REPLACEMENT PAGES FOR THE  
CALVERT CLIFFS UNIT 1, CYCLE 11 RELOAD ANALYSIS

## CLARIFYING INFORMATION ON THE UNIT 1, CYCLE 11 RELOAD ANALYSIS

Based upon discussions with the NRC Staff, the following clarifications are provided.

SKETCHES OF BATCH N VERSUS BATCH L FUEL

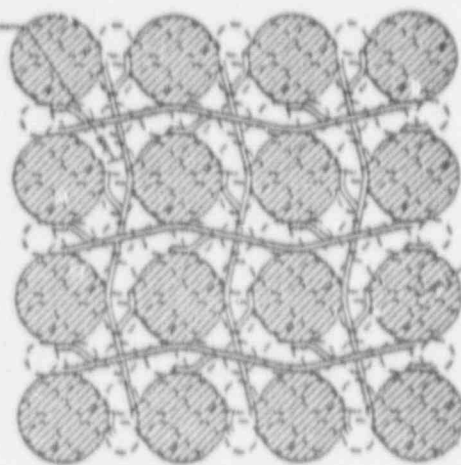
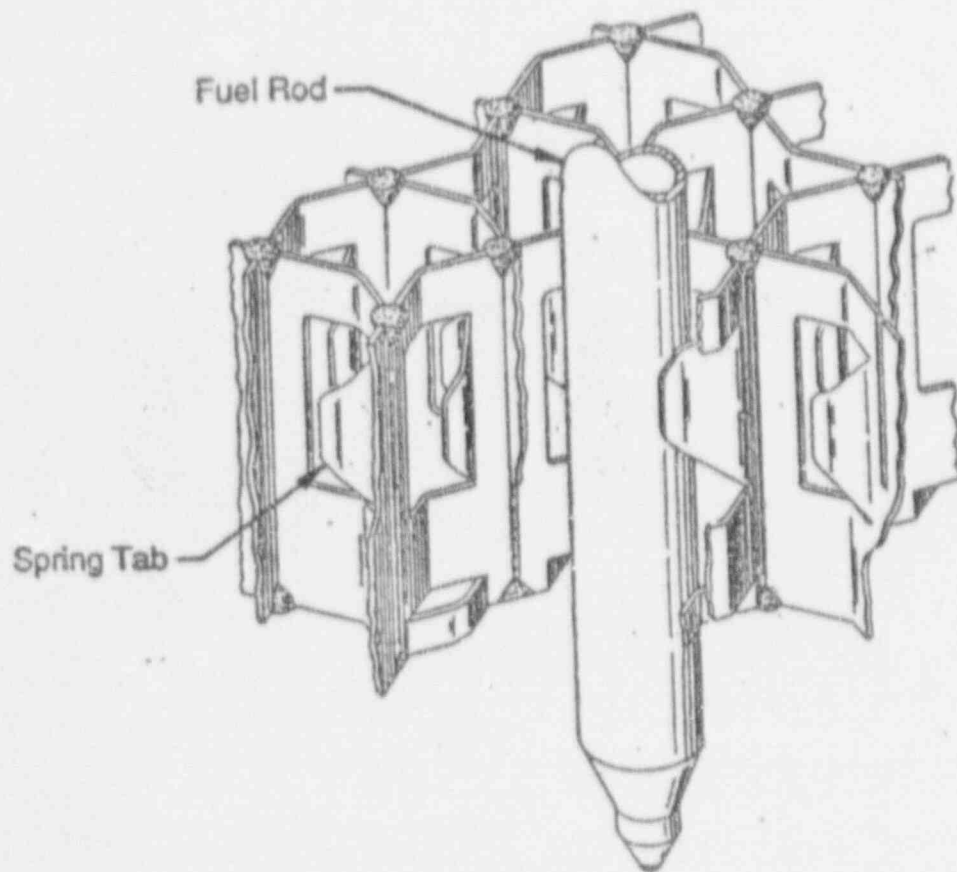
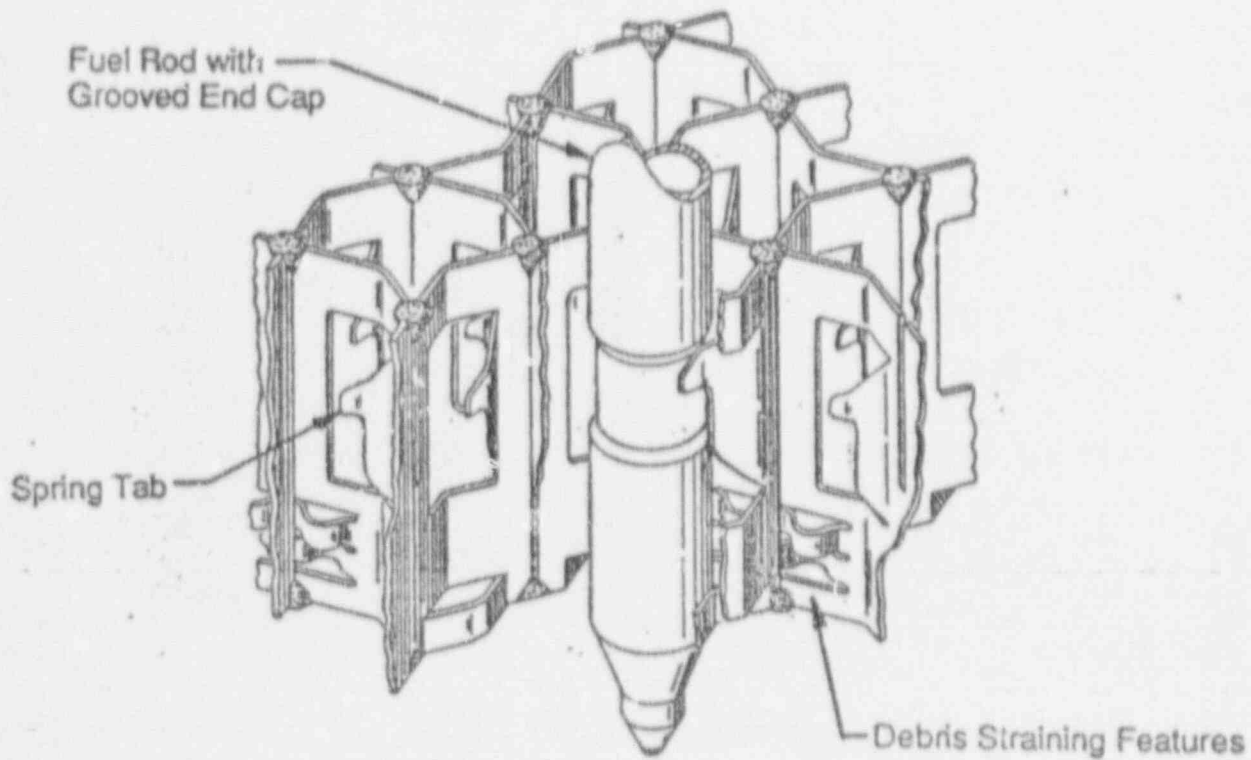
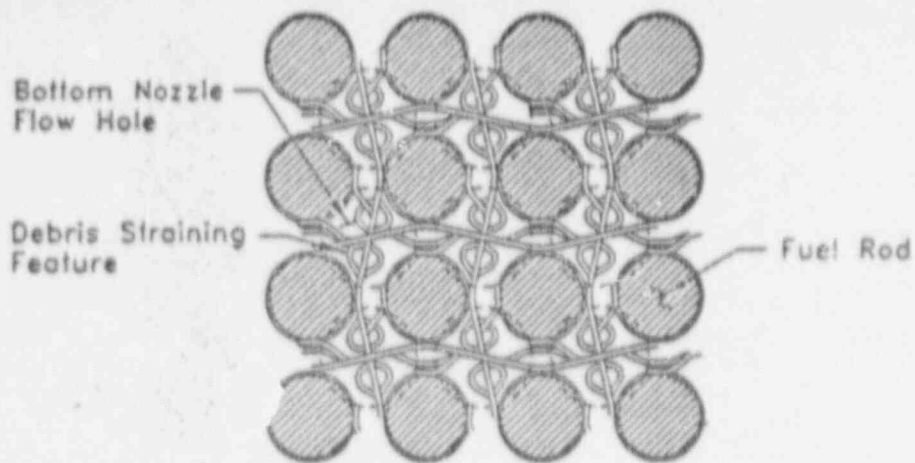
- 4) Provide a sketch showing the details of Batch N fuel versus Batch L fuel.

A sketch is provided in Attachment (3).
